ADDENDUM NO. 3, APRIL 30, 2009

RE: Ocean Avenue Elementary School
Portland, Maine
A/E Comm. No. 3316.10

City of Portland RFP No. 7109
BGS project No. 723

FROM: WBRC Architects-Engineers
141 Preble Street
Portland, Maine 04101
Tel: (207) 828-4511

ADD3-ES501-1

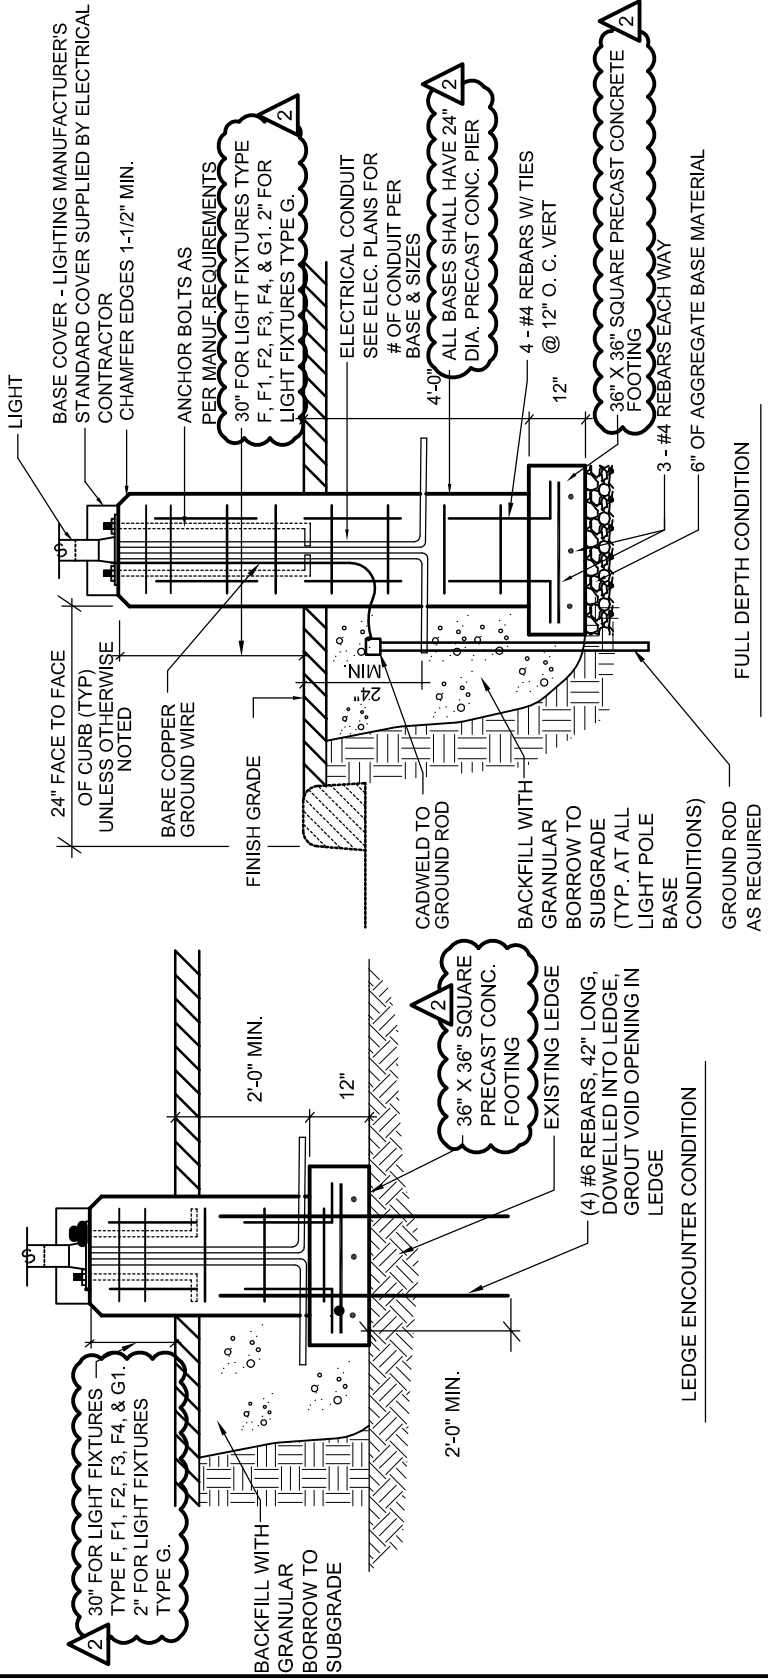
36. Sheet ES501, Site Electrical Details, REVISE portions as indicated on Sketch ADD3-ES501-1.

NOTE
 PRECAST CONCRETE LIGHT
 POLE BASES SHALL BE
 PROVIDED BY DIV. 26 &
 INSTALLED BY DIV. 31.
